- Request - Special Use Permit for a New Gas Station
- Location - 1405 Bernath Parkway (South-East Corner of Airport Highway and Bernath Parkway)
- Applicant / Developer - Skilkengold Development, LLC  
4270 Morse Rd  
Columbus, OH 43230
- Owner - Sheetz, Inc.  
5700 Sixth Ave  
Altoona, PA 16602
- Engineer - Civil & Environmental Consultants, Inc  
250 W Old Wilson Bridge Road, Suite 250  
Worthington, OH 43085

The staff recommends that the Toledo City Plan Commission recommend approval of SUP-2004-24, a Special Use Permit for a new gas station at 1405 Bernath Pkwy to the Toledo City Council, for the following two (2) reasons:

SPECIAL USE PERMIT  
TOLEDO CITY PLAN COMMISSION  
REF: SUP-2004-24  
DATE: May 9, 2024  
TIME: 2:00 P.M.

**SITE LAYOUT PLAN**

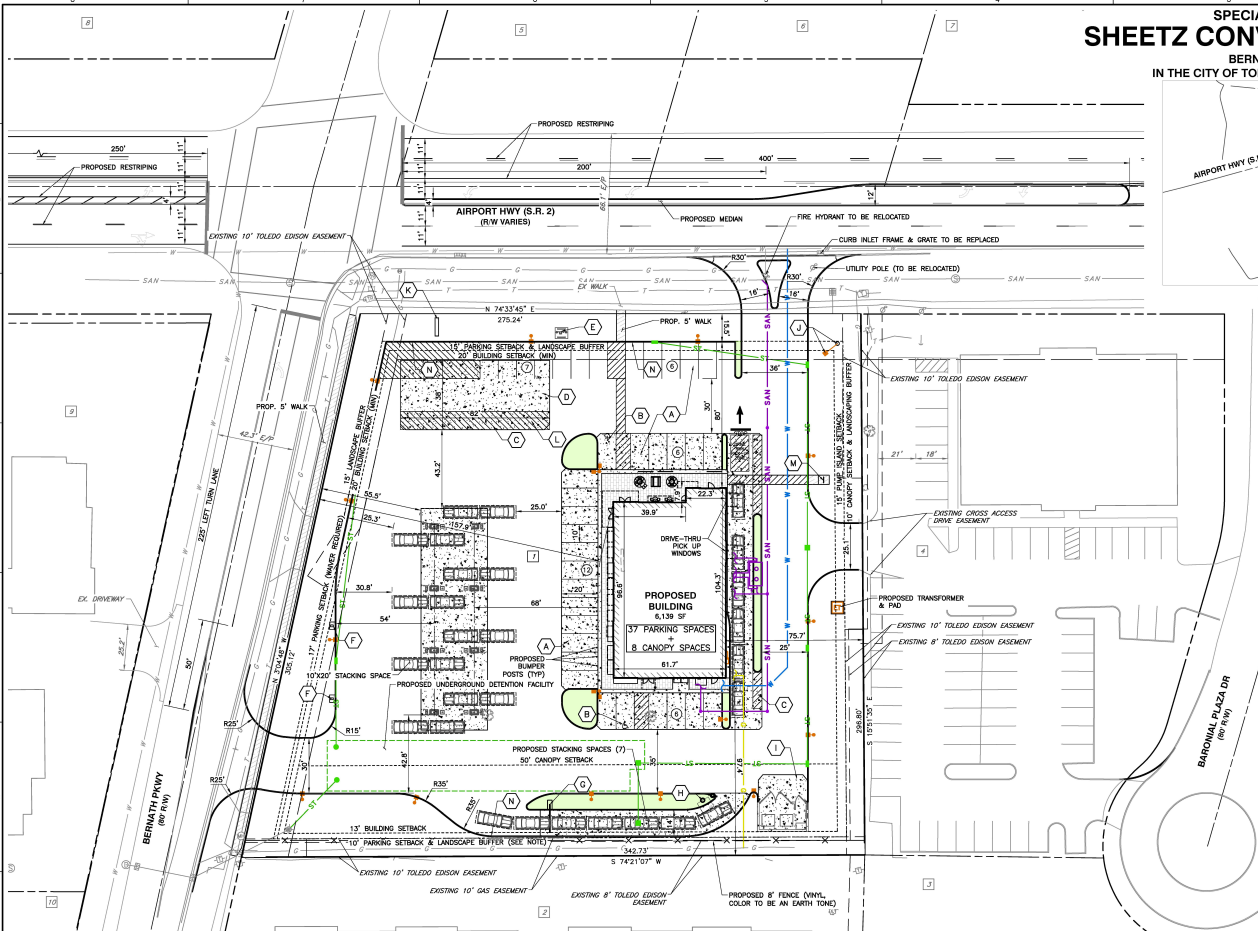
Ingress/Egress to commercial parking lots such as the proposed must be from a major street or from a street without residential zoning on the opposite side of the street. The applicant proposes an ingress/egress drive off Bernath Parkway, which has residential zoning and uses across the street. A waiver will be required. Staff is supportive of a waiver of this requirement as the proposed site reduces the number of commercial ingress/egress drives off Bernath Pkwy from the current two to the proposed one. There are also no other good access points to the site. Only a right-in right-out drive is permitted off Airport Hwy.

TMC§1108.0204(B)(7) requires landscaped terminal islands at the end of each parking row. A landscaped terminal island is not shown at the western end of the parking row shown along Airport Hwy. A landscaped terminal island will be required at that location.

The dumpster enclosure is screened correctly with a combination of evergreen plantings and a fence; however, dumpsters are required to be located as far away from residential areas as possible. The site plan currently shows it along the southern property line. The dumpster will need to be moved to the eastern property line.

43. Dumpster location(s) shall be clearly defined, have a concrete pad and be surrounded by a solid wooden fence or a masonry screen enclosure with landscaping and shall not be located in any required setbacks or the public right-of-way as stated in TMC§1361.10(b)(10) of the Building Code. Dumpster location(s) shall also be as far away from residential areas as possible. **Not acceptable as depicted. Dumpster enclosure must be moved to eastern property line.**

- g. Landscaped terminal islands are required at the end of each parking row. **Not acceptable as depicted. Landscaped terminal island is required at the western end of the parking row shown along Airport Hwy.**

1 FRONT ELEVATION  
TOP 11'0"

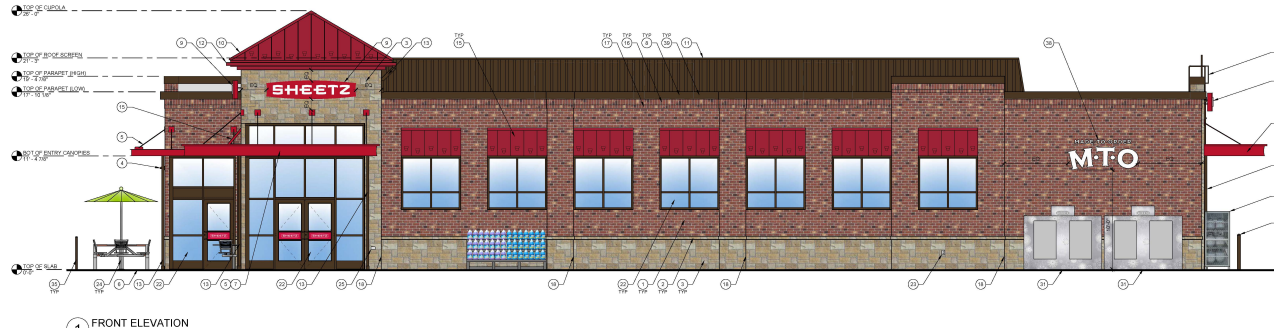
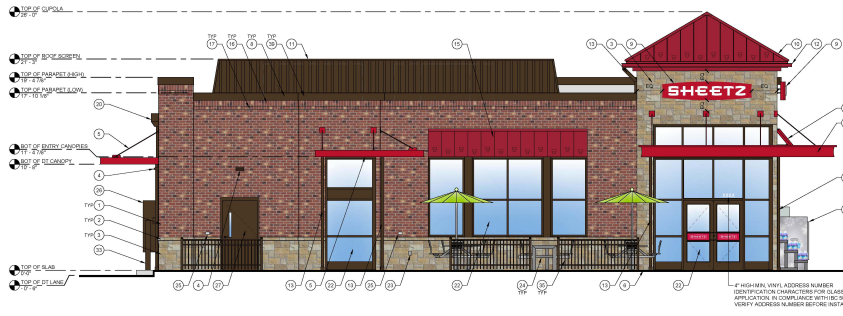
TMC§1109.0205 *Building Design Standards* requires variation in massing and wall articulation for facades facing streets and walkways. The façade facing Bernath Parkway has a span of wall over fifty feet (50') in length with only non-recessed windows and window awnings to vary its mass and articulation. The applicant must articulate this wall by using features such as columns, ribs or pilasters, piers, and fenestration pattern. The section also requires the building's design to reduce its perceived height by dividing the building mass into smaller scale components. The building has a clearly defined base; however, it is lacking a well-defined top beyond the front corner tower. The façade facing Bernath Parkway must have a better-defined top by using features such as distinct and multiple architectural roof forms, clearly pronounced eaves, and distinct parapet designs and cornice treatments.

- a. Elevation facing Bernath Parkway must be articulated in order to add architectural interest and variety and avoid the effect of a single, long or massive wall with no relation to human size. **Articulation shall be visually established by using architectural features such as columns, ribs or pilasters, piers, and fenestration pattern.**

- b. Elevation facing Bernath Parkway must have a better-defined top by using features such as distinct and multiple architectural roof forms, clearly pronounced eaves, and distinct parapet designs and cornice treatments.

# CANOPY DETAILS

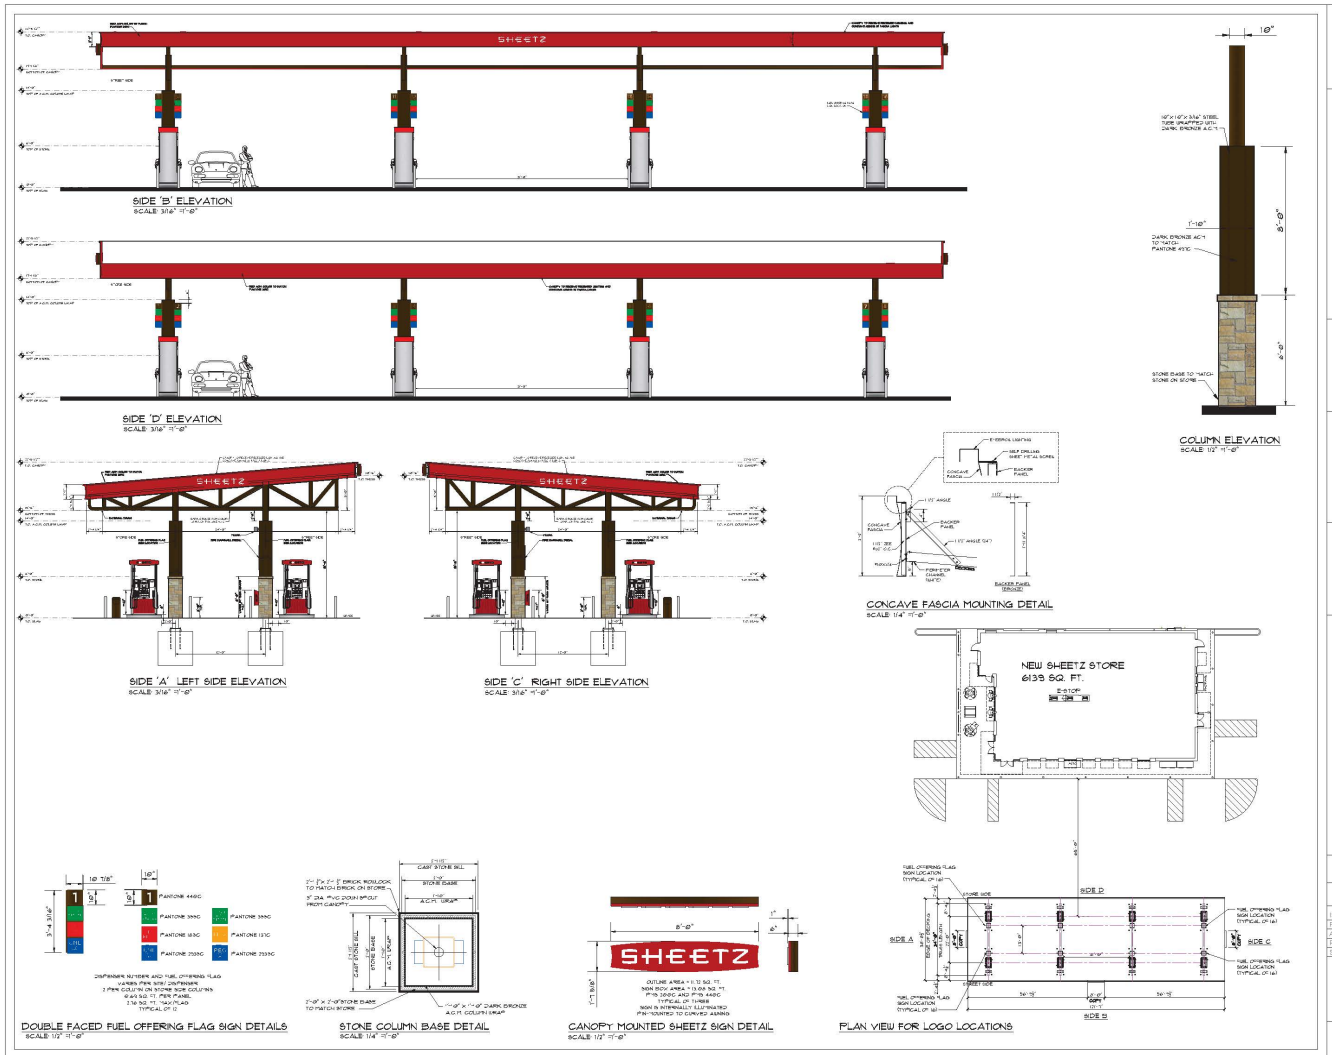
Support columns must be brick or stone compatible with the principal building per TMC§1104.0903(A). This brick or stone finish must span the entire column up to the canopy. A brick or stone base must also be added to the drive-through order point.

- c. Canopy support columns must be brick or stone which is compatible with the principal building's brick or stone. **Brick or stone finish must span the entire column up to the canopy.**
